**TRACY DEFENSE DEPOT (USARMY)
EPA ID: CA4971520834
OU 01
TRACY, CA
07/31/2001**

Explanation of Significant Differences to the Selected Remedies in the ROD for SWMUs 2, 3, 7, and 33, Building 30 Drum Storage Area, and the Northern Depot Soils Area

FINAL

41-F0602236.00 00353
31 July 2001

Figure 2-1.
Location of Solid Waste Management Unit 4
Defense Distribution Depot San Joaquin, Tracy Site

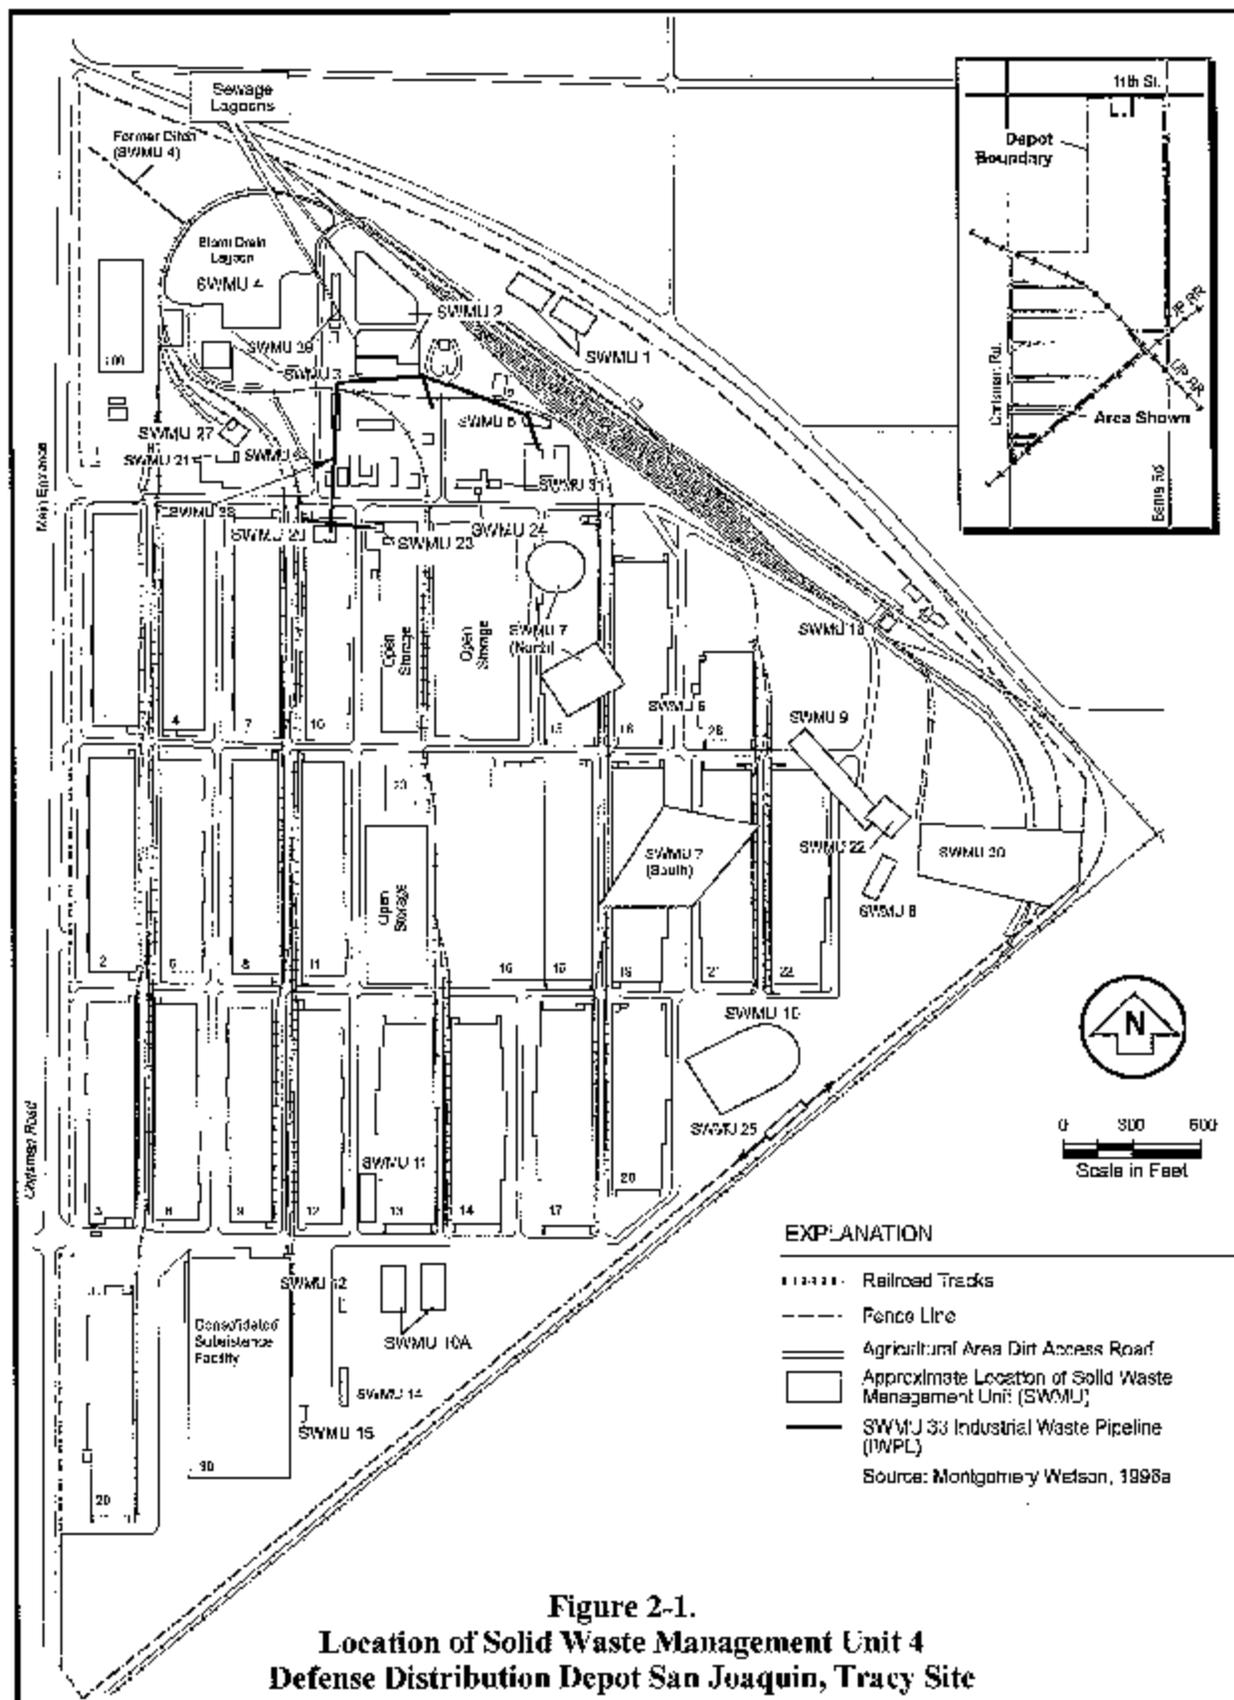
2.5.4 Changes include deleting excavation and disposal of sediment from the Storm Water Detention Pond. The revised selected remedy still requires the construction of an overflow weir to prevent sediment from being discharged in the storm water. The immediate construction of a sediment trap will be deferred pending an evaluation of the ability of the weir to retain sediment.

Figure 4-1.
Soil Contamination in Northern Depot Area and Previous Sampling Locations
Defense Distribution Depot San Joaquin, Tracy Site

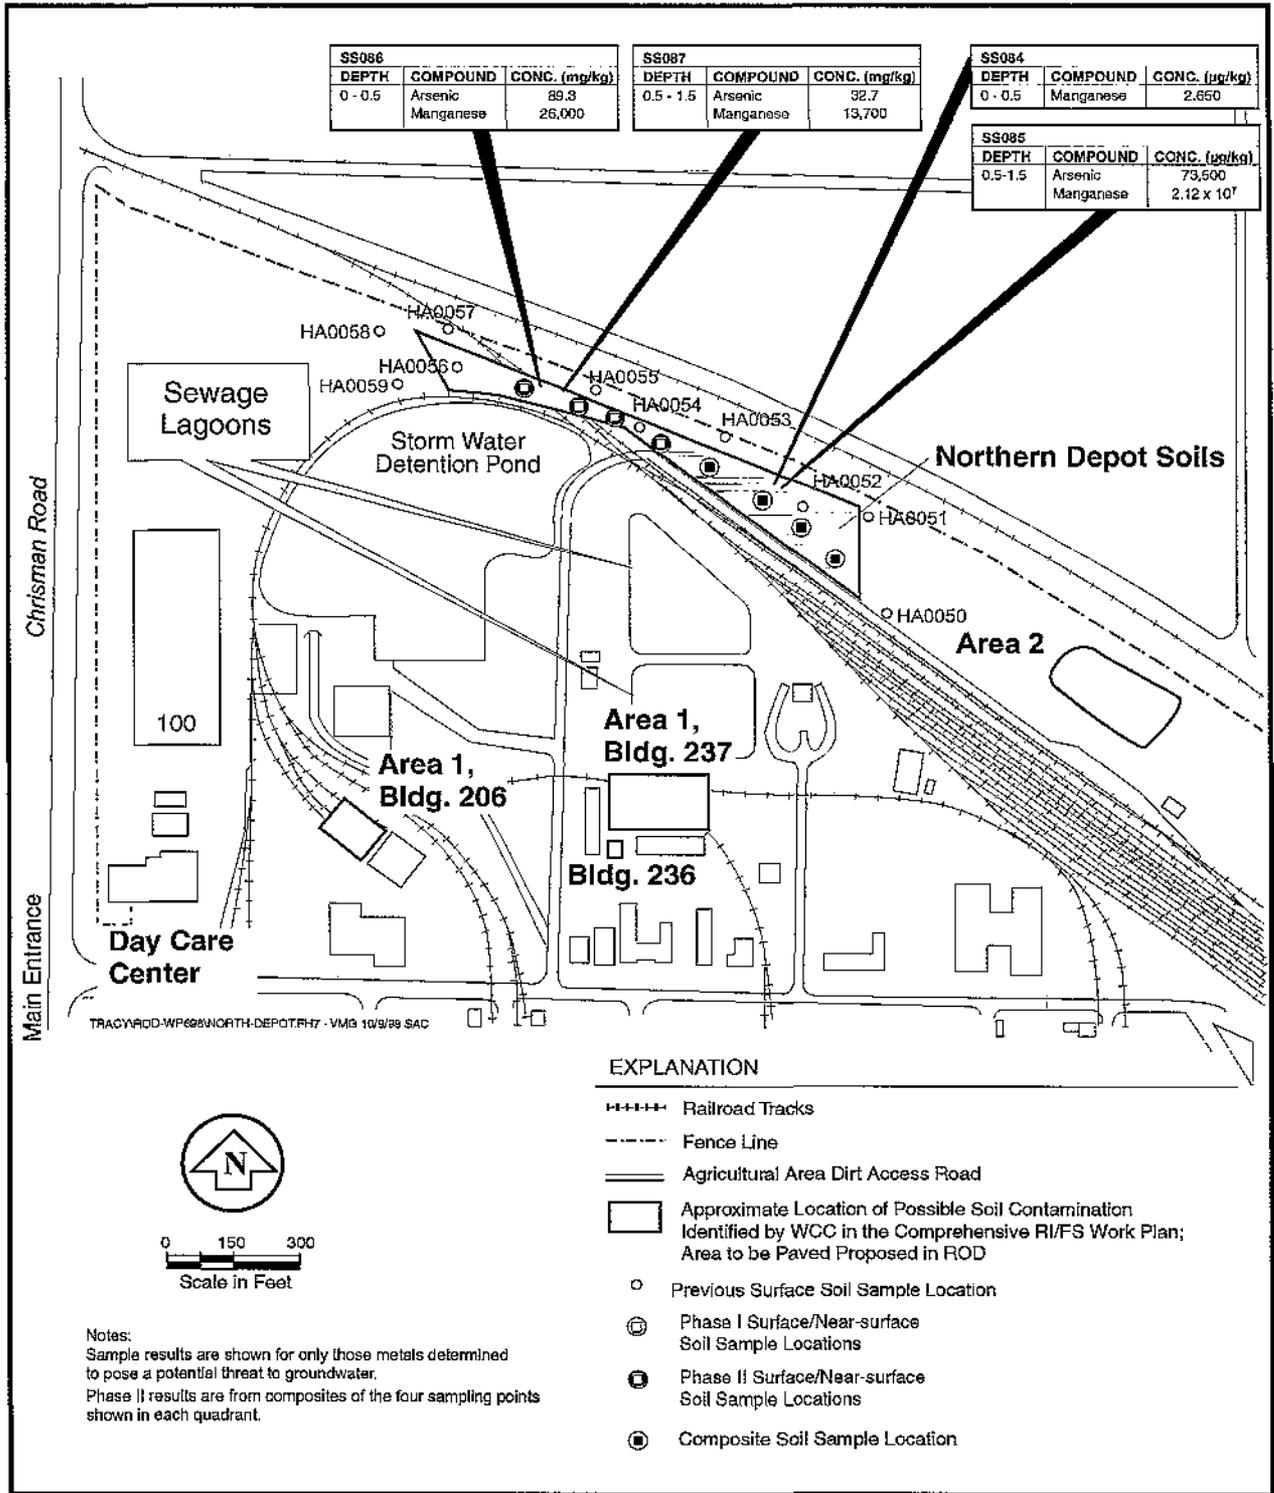
4.3.2 The soil in the Northern Depot Area at DDJC-Tracy requires remediation to address unacceptable risks to human health. However, the units for the arsenic and manganese concentrations in Table 8-14 of the RI/FS (Montgomery Watson, 1996b) and in the table following paragraph 9.7.9.3 of the ROD (Radian, 1998a) were incorrect. This conclusion was confirmed by reviewing Table C-65 in *Comprehensive Site-Wide Baseline Risk Assessment* (Montgomery Watson, 1996a). Table C-65 provides the data that were used as a basis for calculating background levels and cleanup standards. The exposure point concentrations in Table C-65 are in mg/kg, not µg/kg. Cleanup standards are obtained by dividing the exposure point concentration by the total hazard quotient.

4.3.3 For arsenic, the cleanup standard is calculated as:

**Institutional Controls for Building 30 – Drum Storage Area
Defense Distribution Depot San Joaquin - Tracy**

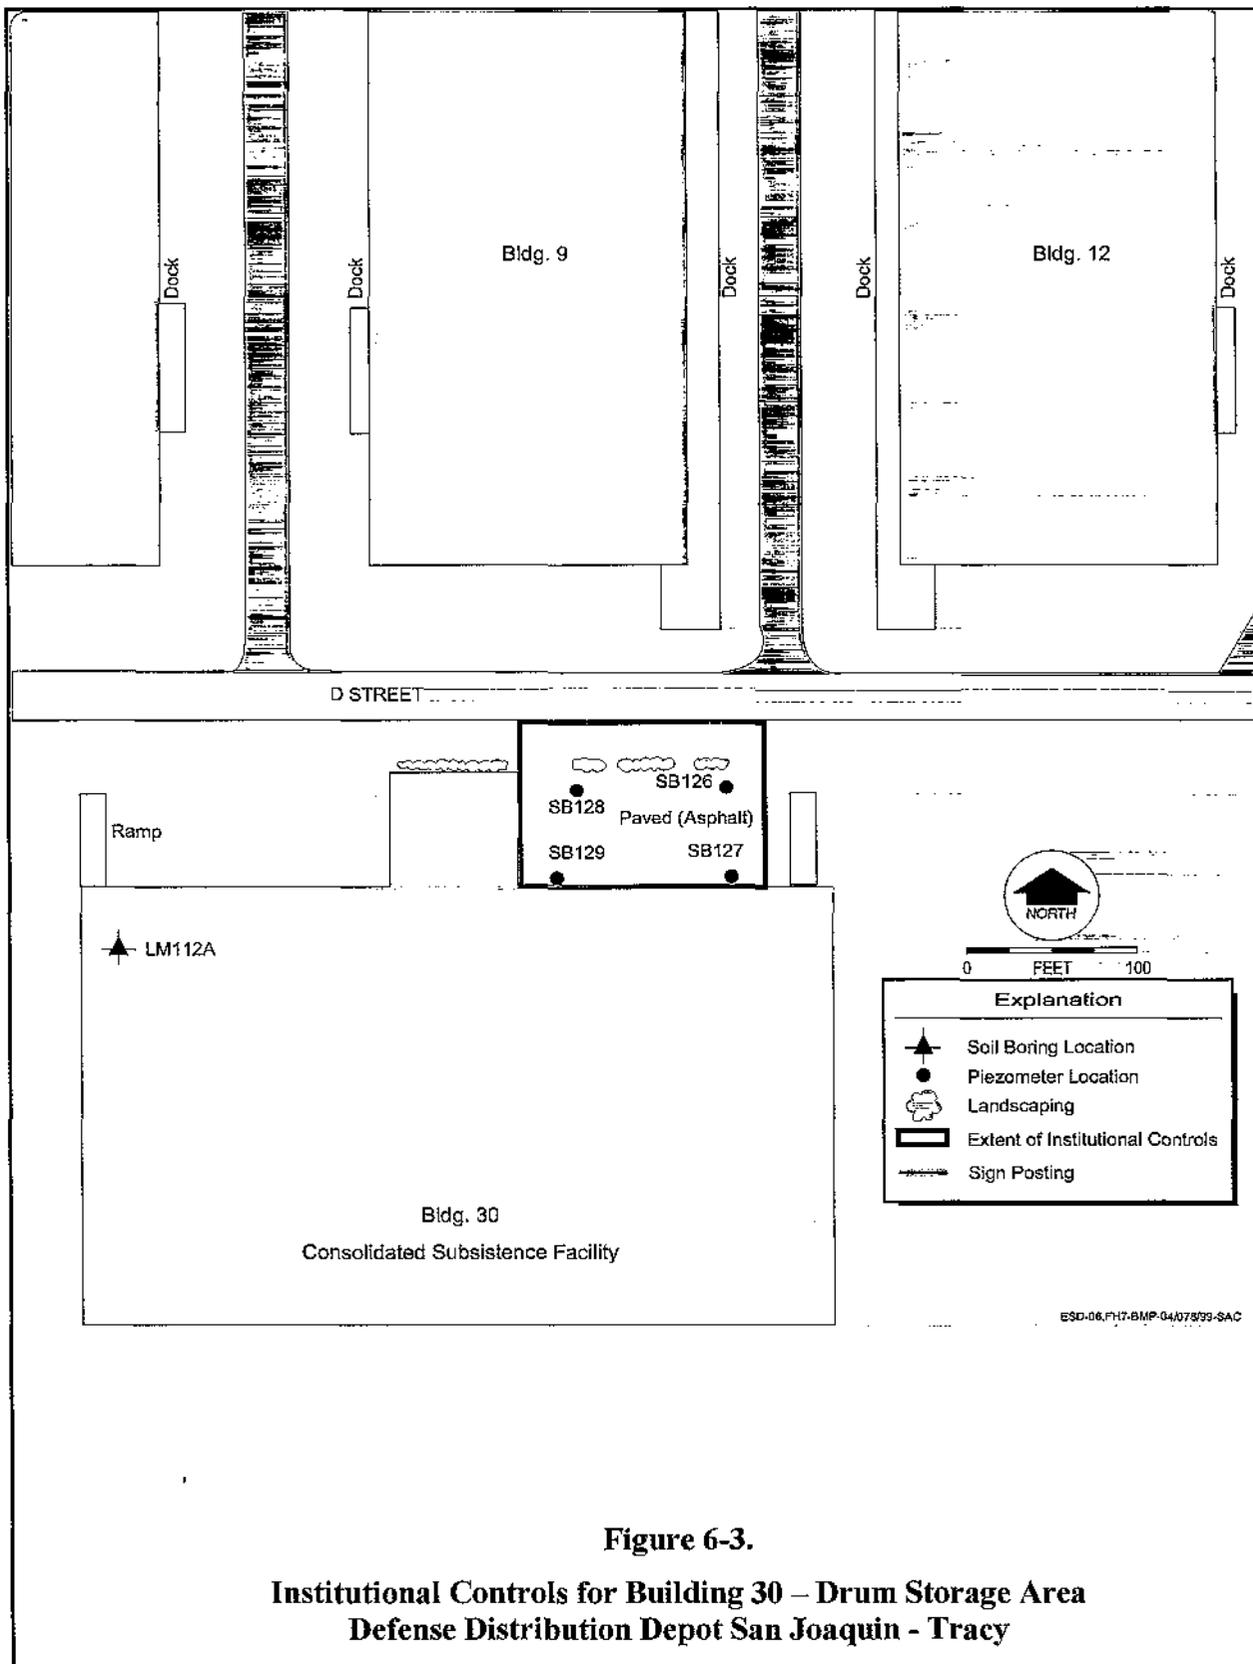
6.4.5 The selected remedy specifies that for Building 30 and the pavement within the affected area shown in Figure 6-3 the signatory parties to the ROD must be notified at least 90 days before any demolition or construction activities that could expose contaminated soil. The notification shall include:

Figure 6-4
Institutional Controls for
SWMU 33- Industrial Waste Pipeline
Defense Distribution Depot San Joaquin - Tracy

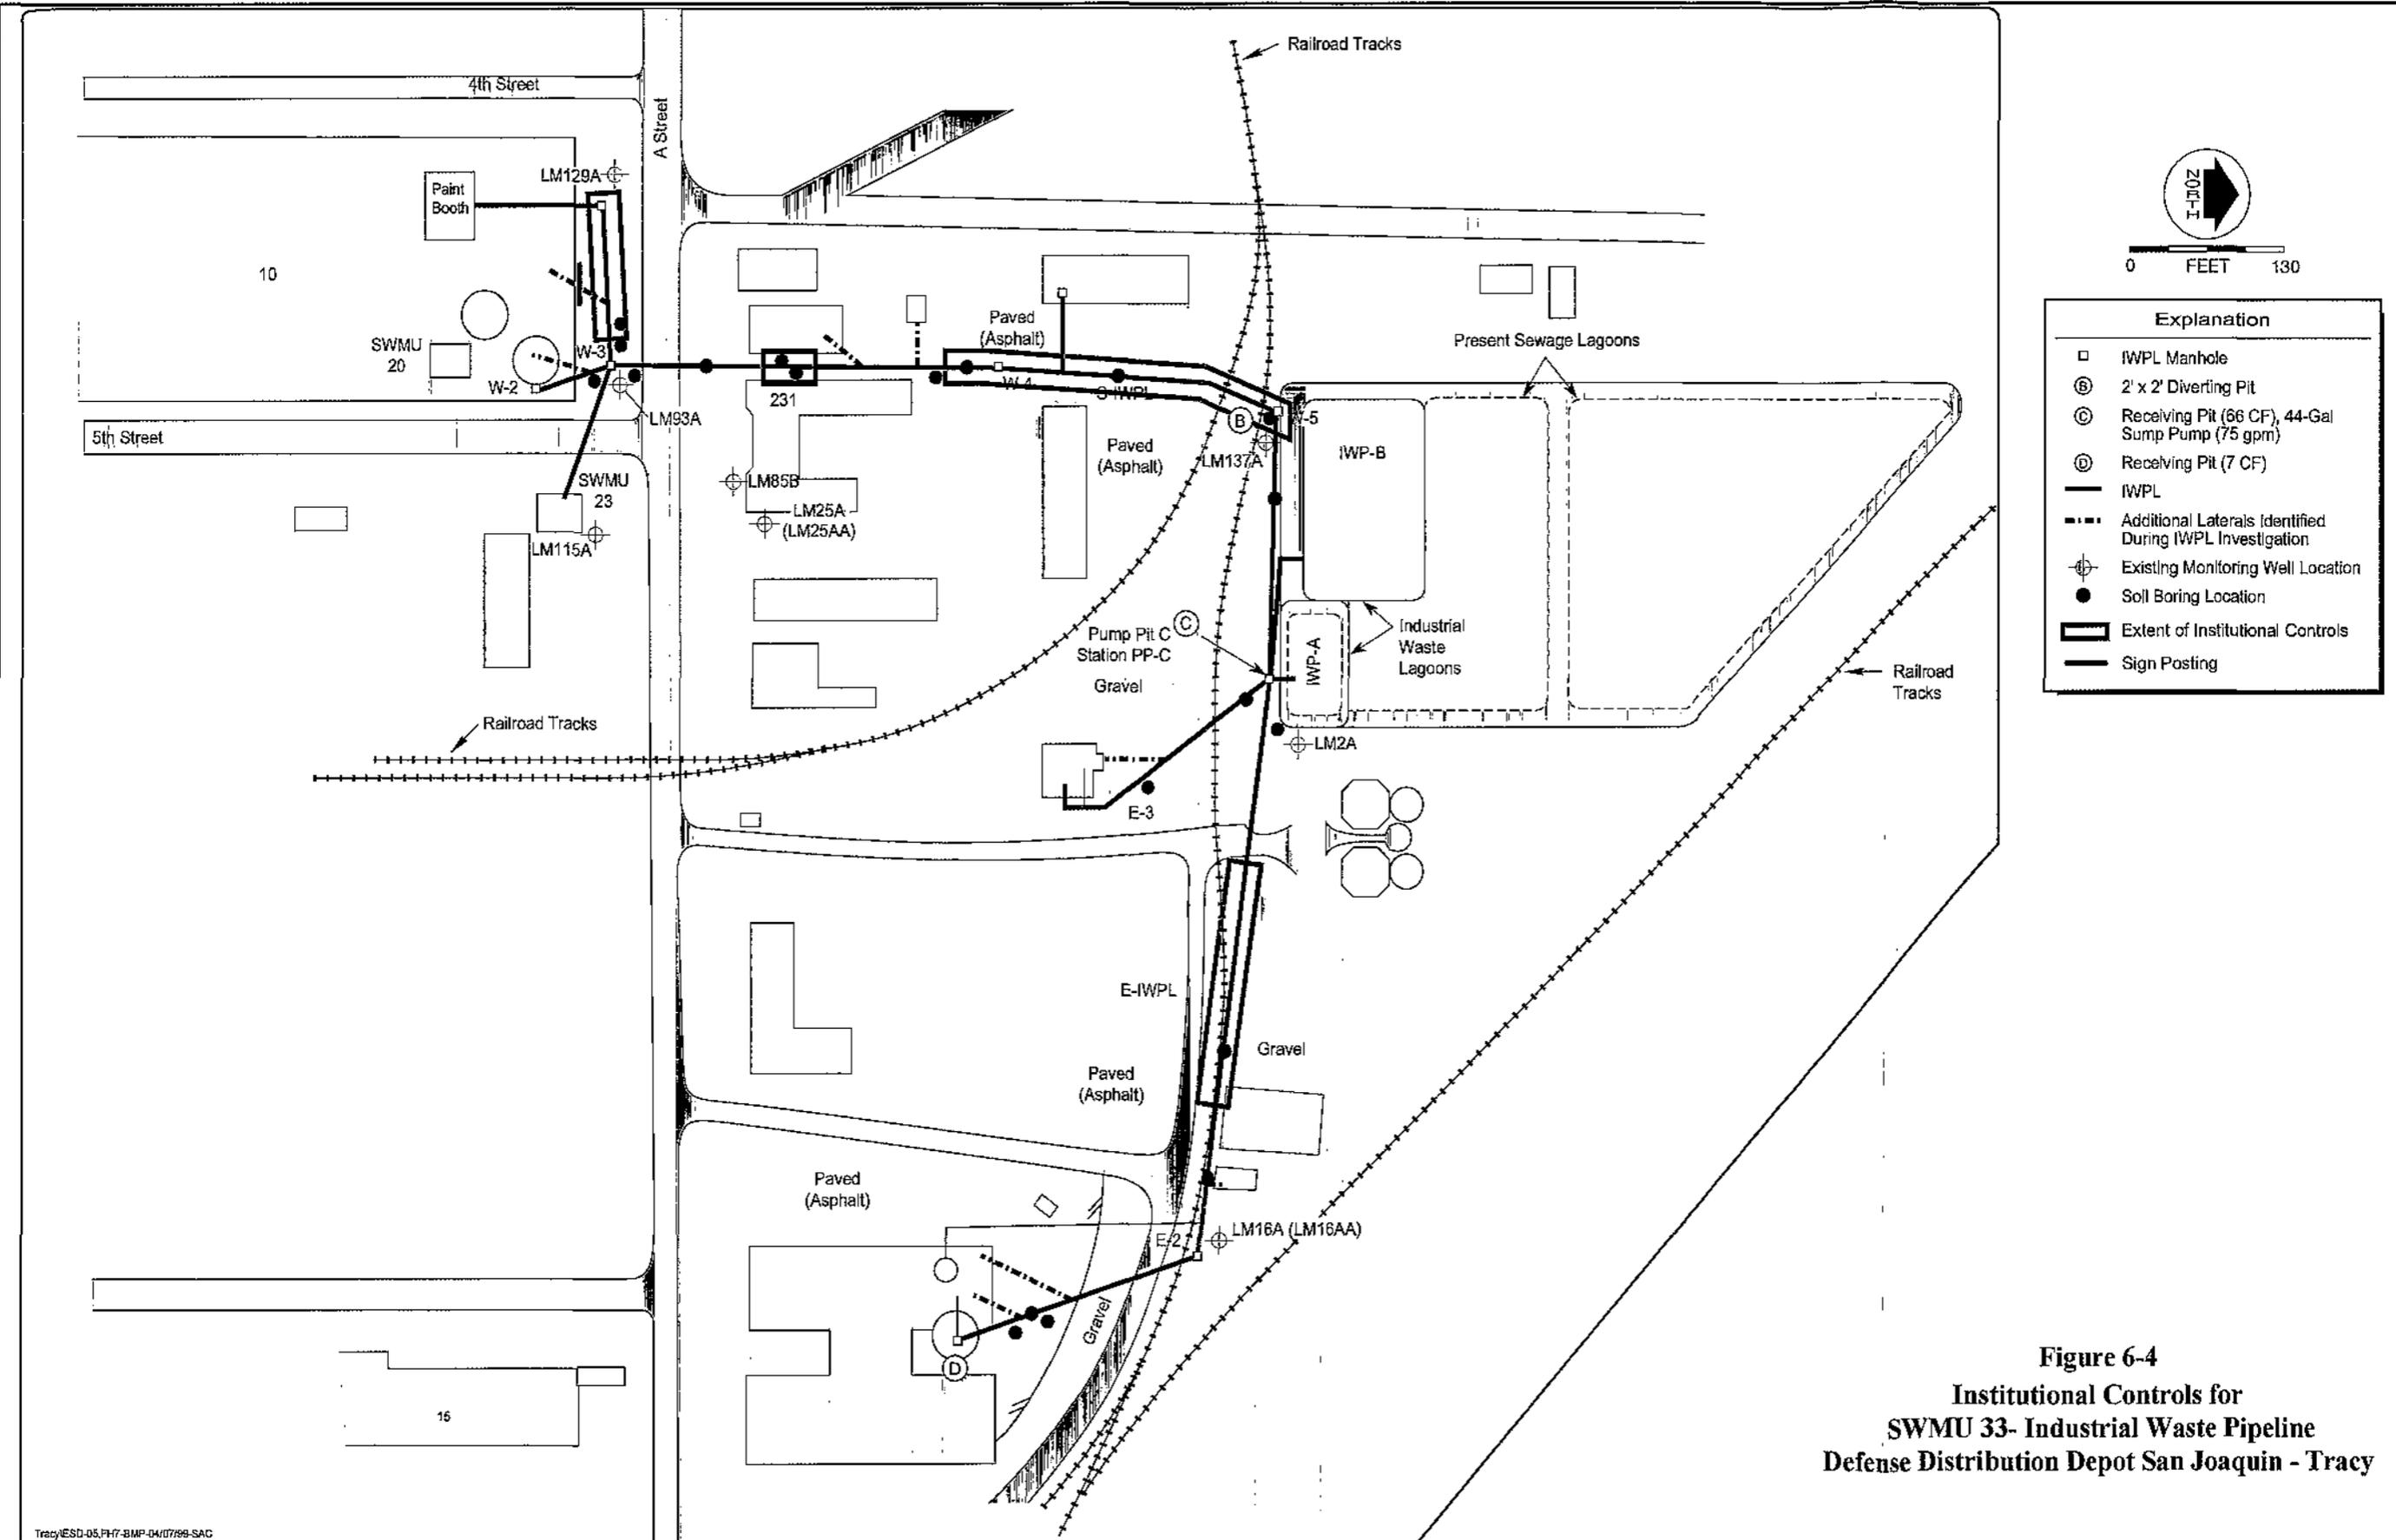
6.5.5 The selected remedy specifies that for the affected areas of the IWPL shown in Figure 6-4, the signatory parties to the ROD must be notified at least 90 days before any demolition or construction activities that could expose contaminated soil. Figure 6-4 identifies portions of the IWPL that have restricted use. These areas are known to have contaminants present in concentrations that are greater than the cleanup standards identified above. The notification shall include:
